Re: Railway (Metrolink - Estuary to Charlemont via Dublin Airport) Order [2022]
Metrolink. Estuary through Swords, Dublin Airport, Ballymun, Glasnevin and City Centre to
Charlemont, Co. Dublin

**Re: Railway (Metrolink–Estuary to Charlemont via Dublin Airport) Order 2022 –
Submissions by the Commissioners of Public Works in Ireland**

This submission is made in response to the statutory review of the Draft Railway Order. Accordingly, this submission has been prepared in the context of “Draft Railway Order 2022; MetroLink - Estuary to Charlemont via Dublin Airport” which seeks to deliver the construction of a fully segregated and automated railway and metro mostly underground c. 18.8km in length with 16 stations running from north of Swords at Estuary through Swords, Dublin Airport, Ballymun, Glasnevin, and the City Centre to Charlemont. The Draft Order is currently on public display. We would respectfully request that An Bord Pleanála consider the content within this submission. DOWNEY would like to thank the Board for the opportunity to make this submission, on behalf of the Commissioners of Public Works in Ireland (hereinafter the Office of Public Works (OPW), a prescribed body f

Figure 15. Plan showing horizontal alignment in Relation to 1GQ (extract from ML1-JAI-EIA-ROUT_XX-DR-Y-05025)

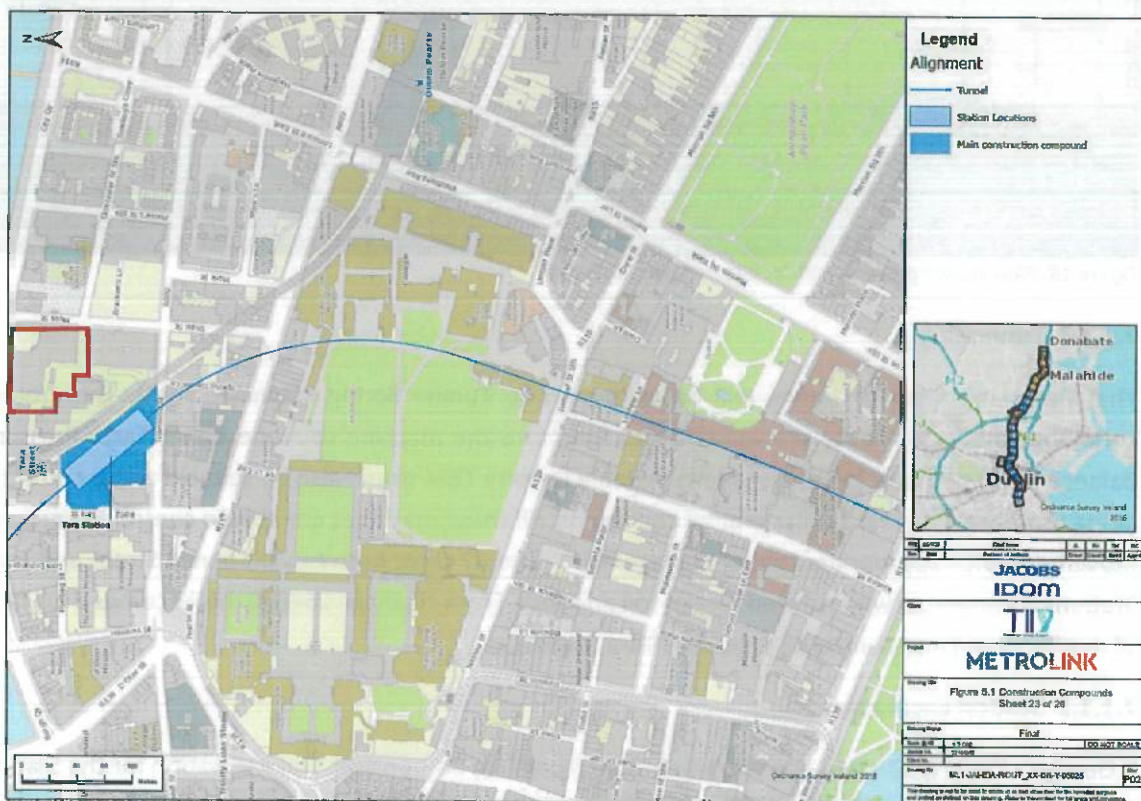
Tara Station is approximately 85m southwest of this property. The alignment drawing ML1-JAI-EIA-ROUT_XX-DR-Y-05025 and the Contour drawing ML1-JAI-EIA-ROUT_XX-DR-Y-21147 show the alignment and the predicted ground movement.

Figure 16. Plan showing Geological Section in Relation to 1GQ

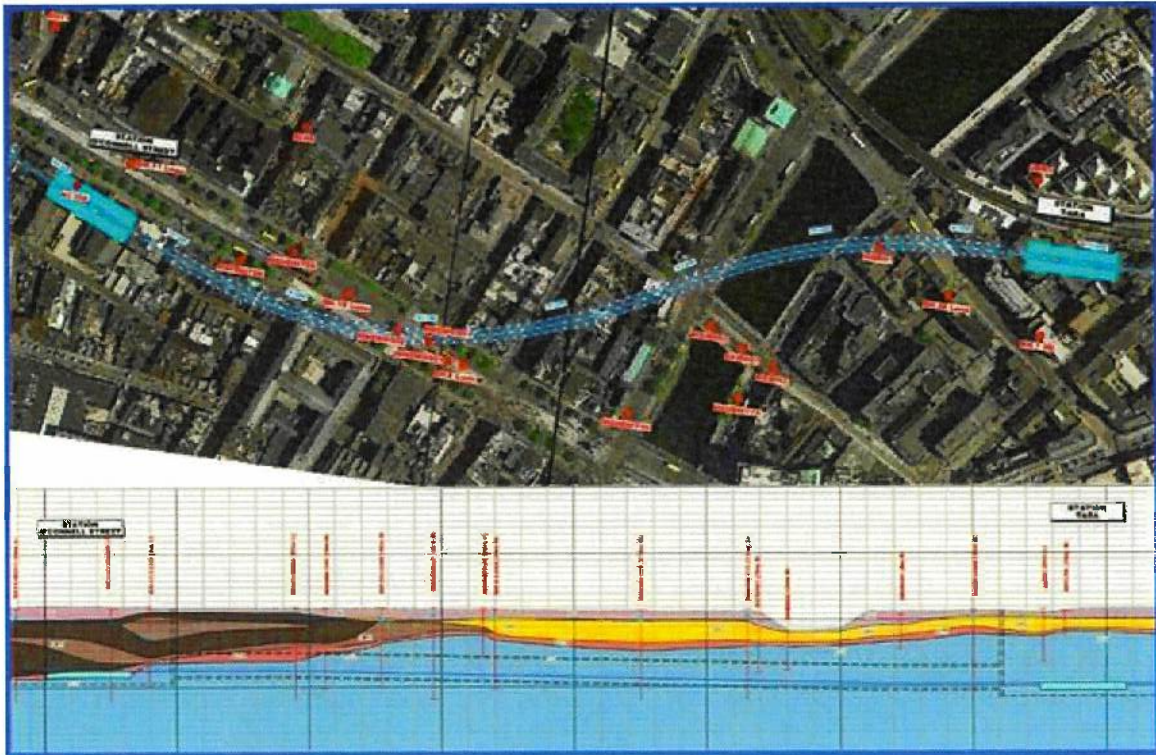
Adjacent to the 1GQ, the proposed MetroLink will be excavated through Argillaceous Limestone rock (CLU) underlying Weathered Rock (QTR) underlying Brown Boulder Clay (QBR), containing extensive fluvio-glacial sands and gravels. Cover to the tunnel crown is approximately 17m comprising Brown Boulder Clay. The invert will be excavated through both weathered and unweathered limestone. This will present a significant challenge to ground movement mitigation using tunnel management.

Figure 17. Plan showing horizontal alignment (extract from ML1-JAI-EIA-ROUT_XX-DR-Y-04026)

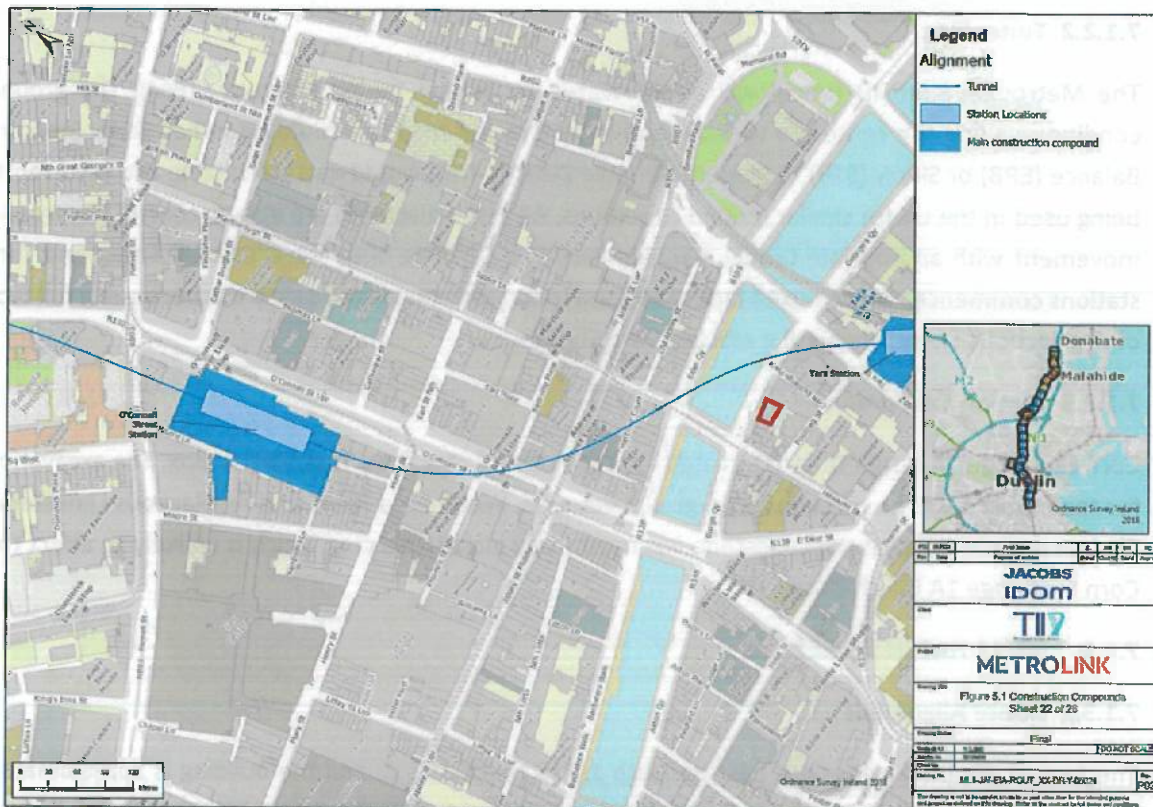
The MetroLink 8.5m ID running tunnel passes approximately 40m from the front of this building. The alignment drawing ML1-JAI-EIA-ROUT_XX-DR-Y-04026 and 04027 and the Contour drawing ML1-JAI-EIA-ROUT_XX-DR-Y-21147 show the alignment and the predicted ground movement.

Figure 19. Plan showing horizontal alignment (extract from ML1-JAI-EIA-ROUT_XX-DR-Y-05026)

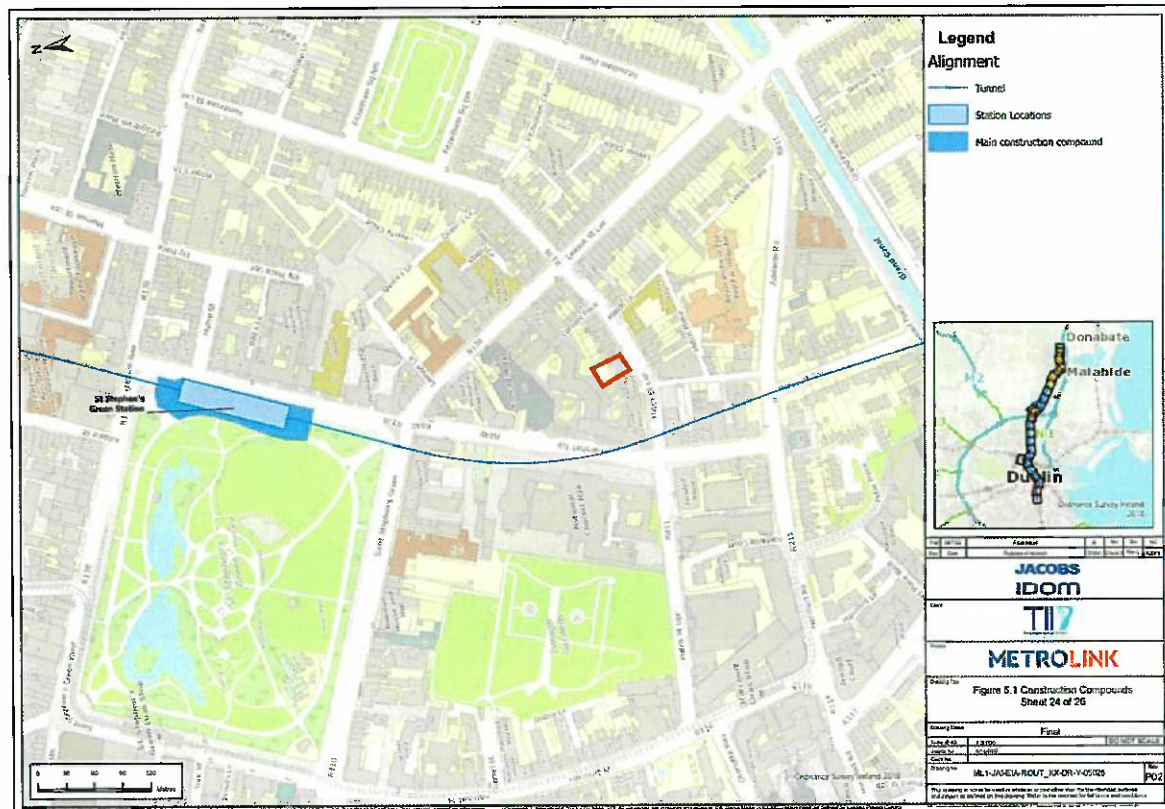
The tunnel alignment does not pass beneath 13/15 Hatch Street, and the building is approximately 75m to the east of the alignment. The alignment drawing ML1-JAI-EIA-ROUT_XX-DR-Y-05026 and the Contour drawing ML1-JAI-EIA-ROUT_XX-DR-Y-21147 show the alignment and the predicted ground movement.

Many of the reports refer to chainages along the alignment. However, there are no plans that indicate these chainages, and this makes reviewing the Draft Railway Order and EIAR difficult.

Figure 20. C9 Geological Section (ref. A5.13, Diagram 3.14: Geologic Profile for TBM Drive C9- St Stephen's Green to Charlemont)

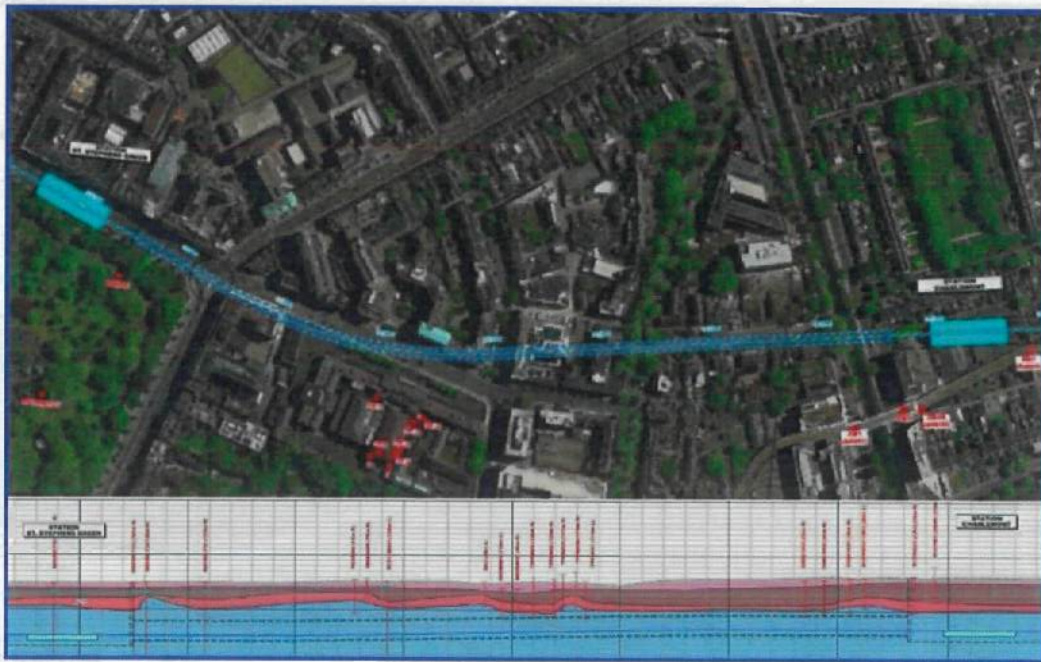
In proximity to 13/15 Hatch Street, the proposed MetroLink 8.5m ID tunnel will be excavated through Argillaceous Limestone rock (CLU) that underlies Brown Boulder Clay (QBR), containing fluvioglacial sands and gravels. Cover to the tunnel crown is 12m including 2m of rock cover.

The area delineated as 13/15 Hatch Street in the above plan is situated approximately 340m from St. Stephen's Green Station Box and approximately over 375m from Charlemont Station Box. The excavation for these stations is unlikely to affect 13/15 Hatch Street.

Figure 21. Plan showing horizontal alignment (extract from ML1-JAI-EIA-ROUT_XX-DR-Y-05025)

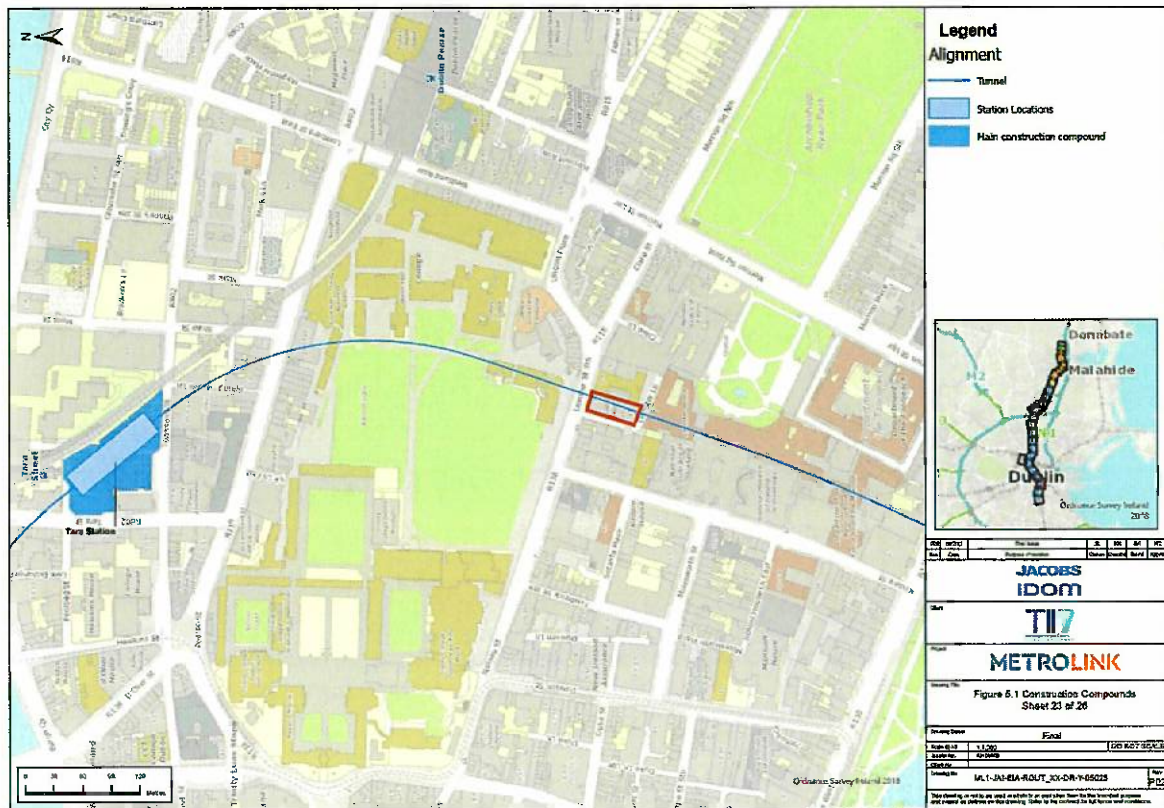
The tunnel alignment passes directly beneath the Trinity Point. However, there is inconsistency in the alignment between Tara Station and St. Stephen's Green. The alignment drawing ML1-JAI-EIA-

ROUT_XX-DR-Y-05025 and the Contour drawing ML1-JAI-EIA-ROUT_XX-DR-Y-21148 show different alignments.

Many of the reports refer to chainages along the alignment. However, there are no plans that indicate these chainages, and this makes reviewing the Draft Railway Order and EIAR difficult.

Figure 22. C8 Geological Section (ref. A5.13, Diagram 3.13: Geologic Profile for TBM Drive C8- Tara Station to St Stephen's Green)

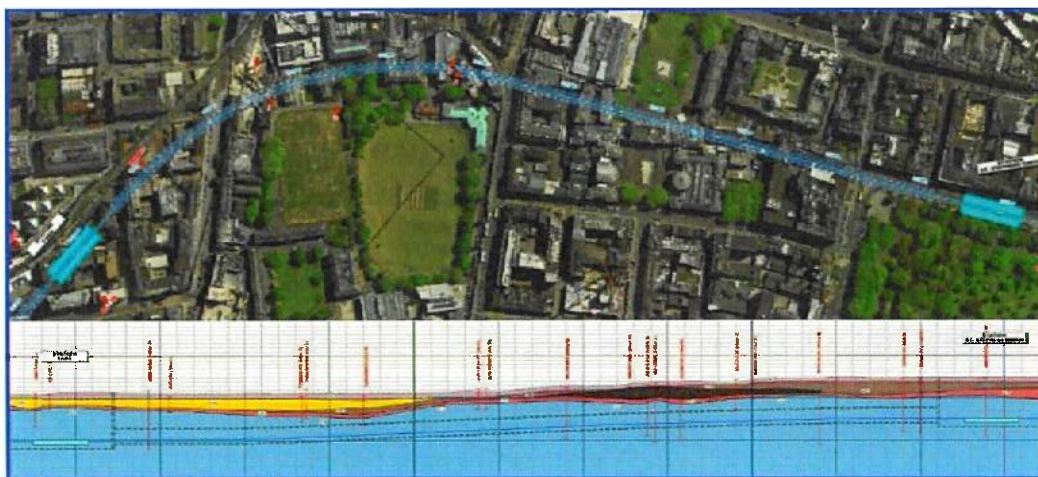
In the proximity of Trinity Point, the proposed MetroLink 8.5m ID tunnel will be excavated through Argillaceous Limestone rock (CLU) that underlies Brown Boulder Clay (QBR), containing fluvio-glacial sands and gravels. Cover to the tunnel crown is 22.75m including 9.75m of rock cover.

The area delineated as Trinity Point in the above plan is situated approximately 540m from Tara Station Box and approximately 385m from St. Stephen's Green Station Box, along the chainage. The excavation for these stations is unlikely to affect Trinity Point.

Figure 23. Plan Showing Horizontal Alignment (extract from ML1-JAI-EIA-ROUT_XX-DR-Y-05026)

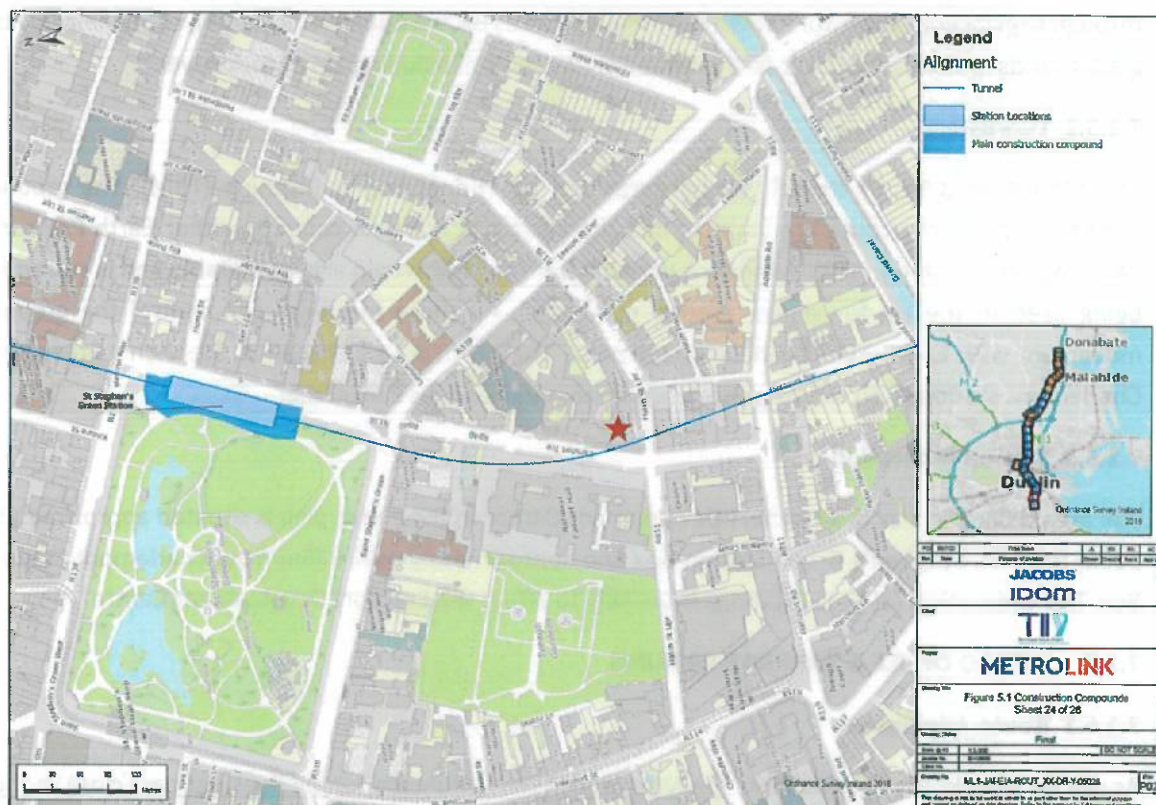
The tunnel alignment passes beneath the Earlsfort Centre. The alignment drawing ML1-JAI-EIA-ROUT_XX-DR-Y-05026 and the Contour drawing ML1-JAI-EIA-ROUT_XX-DR-Y-21148 show different alignments.

Many of the reports refer to chainages along the alignment. However, there are no plans that indicate these chainages, and this makes reviewing the Draft Railway Order and EIAR difficult.

Figure 24. Geological Section ref. A5.13, Diagram 3.14: Geologic Profile for TBM Drive C9- St Stephen's Green to Charlemont

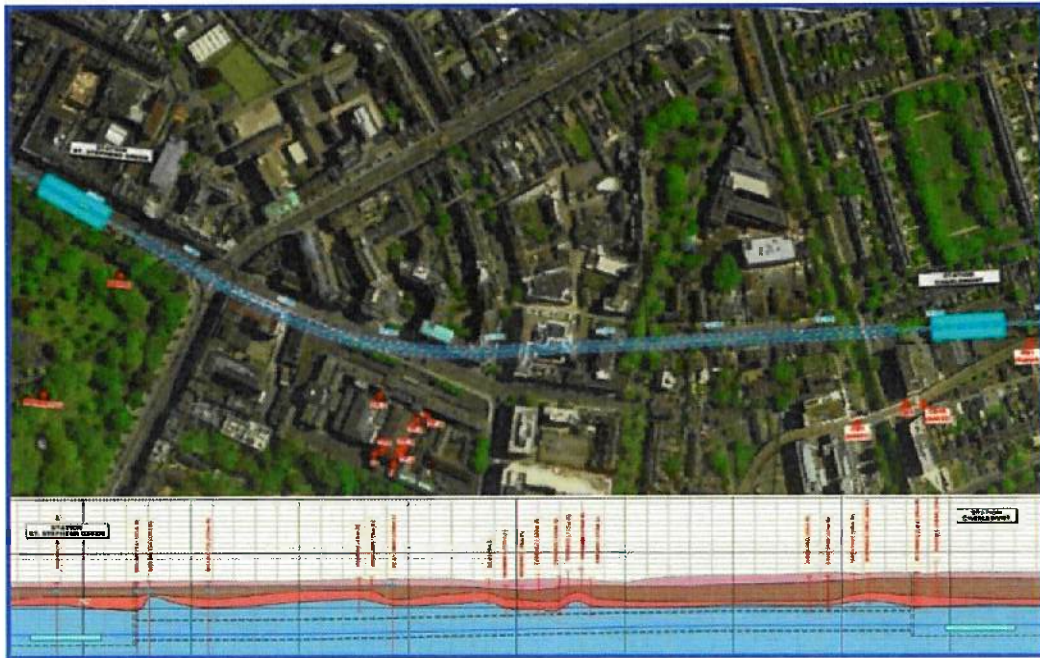
In the proximity of The Earlsfort Centre, the proposed MetroLink 8.5m ID tunnel will be excavated through Argillaceous Limestone rock (CLU) that underlies Brown Boulder Clay (QBR), containing fluvio-glacial sands and gravels. Cover to the tunnel crown is 12m including 2m of rock cover.

The area delineated as the Earlsfort Development Centre in the above plan is situated approximately 300m from St. Stephen's Green Station Box and approximately over 375m from Charlemont Station Box. The excavation for these stations is unlikely to affect the Earlsfort Development Centre.

Figure 25. Plan showing horizontal alignment (extract from ML1-JAI-EIA-ROUT XX-DR-Y-05023)

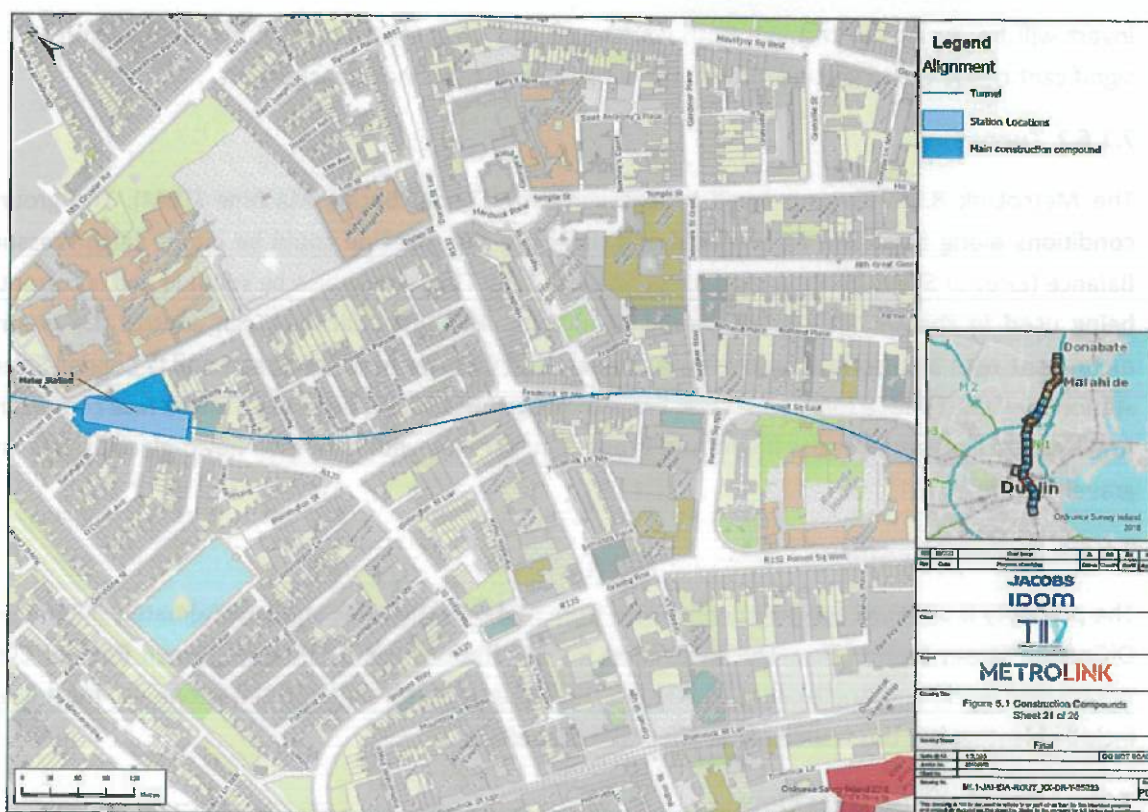
As can be seen in the figure below, the MetroLink 8.5m ID running tunnel does not pass close to this property. The alignment drawing ML1-JAI-EIA-ROUT_XX-DR-Y-05023 and the Contour drawing ML1-JAI-EIA-ROUT_XX-DR-Y-21146 show the alignment and the predicted ground movement.

Many of the reports refer to chainages along the alignment. However, there are no plans that indicate these chainages, and this makes reviewing the Draft Railway Order and EIAR difficult.
